APPLICATION NO.	FILING DATE	FIRST NAMED INVENTOR	ATTORNEY DOCKET NO.	CONFIRMATION NO.
10/710,454	07/13/2004	Robert M. Schmidt	04923 (LC 0159 PUS)	4453
36014	7590	04/14/2009		
Dickinson Wright PLLC 38525 Woodward Avenue, Suite 2000 Bloomfield Hills, MI 48304-5092			EXAMINER FULTON, KRISTINA ROSE	
			ART UNIT 3673	PAPER NUMBER
			MAIL DATE 04/14/2009	DELIVERY MODE PAPER

Office Action Summary	Application No. 10/710,454	Applicant(s) SCHMIDT ET AL.	
	Examiner KRISTINA R. FULTON	Art Unit 3673

DETAILED ACTION

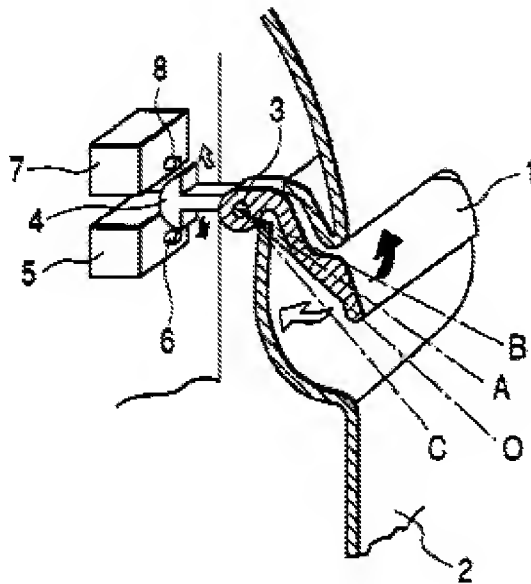
5. Regarding claim 1, Takata teaches a mechanical handle switch assembly integrated within a door of a vehicle and utilized for actuating a vehicle based system, comprising a door handle mechanism (1) coupled to a the door for actuation by a user, being movable in a substantially outboard direction for both actuating the vehicle based system and unlatching the door, a drive train mechanism (4) coupled to said door handle mechanism and being actuated by said door handle mechanism; a switch device (5) operatively coupled to said drive train mechanism and being selectively operated by said drive train mechanism to actuate said vehicle-based system. Further, Takata shows the door handle mechanism is movable within a predetermined travel distance, said predetermined travel distance including a switch-triggering distance (O-A) and an unlatching distance (O-B) that is greater than and inclusive of said switch-triggering distance (see figure below), said door handle mechanism being moved by said switch-triggering distance for actuating said switch device, said door handle mechanism being moved by said unlatching distance for unlatching the door, said unlatching distance sized greater than said witch triggering distance such that a controller can authorize entry prior to said door handle mechanism unlatching the door. See the Takata device below.

6. Regarding claim 5, the door handle mechanism of Takata has a lift configuration for unlatching the door. See figure above.

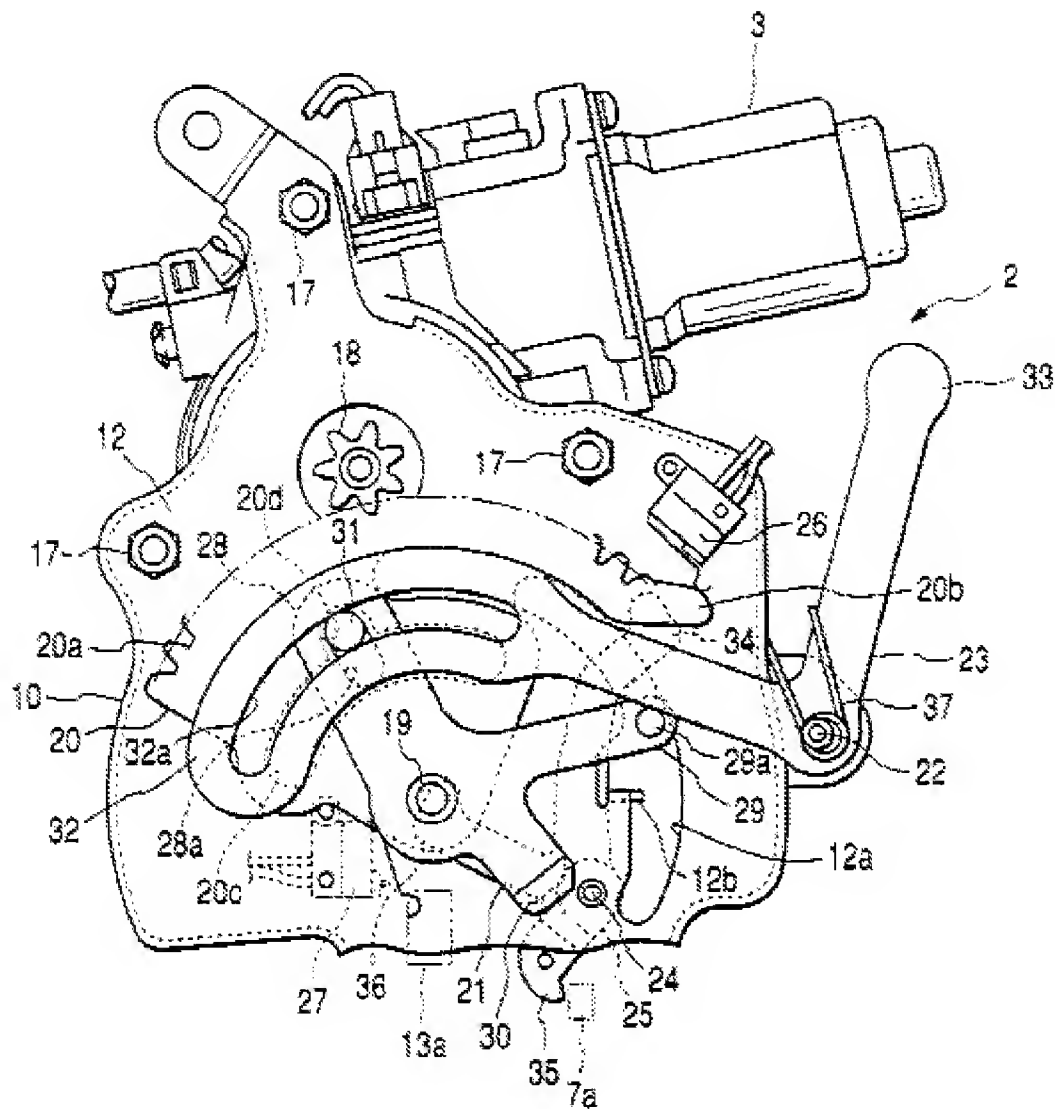
Takata fails to show a drive train mechanism including a first and second gear member, a cam mechanism or a damping mechanism. Takamura and Bella show these features to be well known in the vehicle latch art. Takamura shows a first gear (18) extending, a second gear member (20) operatively coupled to the first gear member and a cam mechanism (20b) integrated with the second gear member and directly contacting a switch device (26). It would have been obvious to one of ordinary skill in the art to replace the drive mechanism of Takata with the drive mechanism of Takamura since replacing one known element with a functional equivalent is considered to be within the level of basic knowledge of a worker in the art. Replacing the Takata drive mechanism with any drive mechanism to translate motion from the handle to the switch would be considered an obvious modification and would yield predictable results as the drive mechanism functions in the Takamura device to relay motion to the switch as necessary in the Takata device. See the Takamura device below.
